<b>Docket Number:</b>	15-IEPR-01
<b>Project Title:</b>	General/Scope
<b>TN #:</b>	203625
<b>Document Title:</b>	Randall Benson's Comments: CoG Analysis of New Nuclear needs a Major Overhaul
<b>Description:</b>	N/A
<b>Filer:</b>	System
<b>Organization:</b>	Randall Benson
<b>Submitter Role:</b>	Public
<b>Submission Date:</b>	2/6/2015 3:28:56 PM
<b>Docketed Date:</b>	2/6/2015

## **CoG Analysis of New Nuclear needs a Major Overhaul**

Figure 1

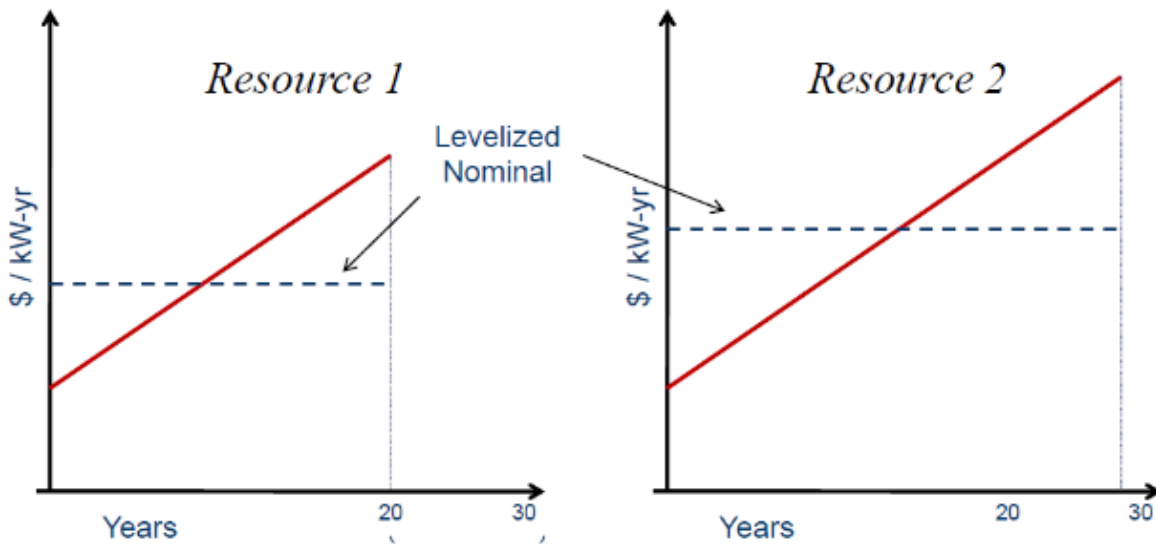
A major flaw exists in CoG’s cash flow accounting that makes it inappropriate to compare between technologies. CoG levelizes the *nominal* cash flow necessary to meet O&M costs, fuel costs, debt service, taxes, etc. This has the effect that technologies with shorter economic lives, *ceteris paribus*, enjoy an artificial advantage over technologies with longer economic lives even when the real, inflation-adjusted net present value of their cash flows and generation are equivalent. Instead of levelizing nominal cash flows, CoG should levelize *real* cash flows. Southern California Edison noted this problem [in a letter to the Energy Commission, date June 1, 2011](#). The next page reproduces a diagram provided by SCE to illustrate the error. It is disappointing that the most recent publicly available version of CoG has not been updated to reflect these comments, as this error contributed significantly to the overestimate of the cost of the AP 1000 in CoG 2009.
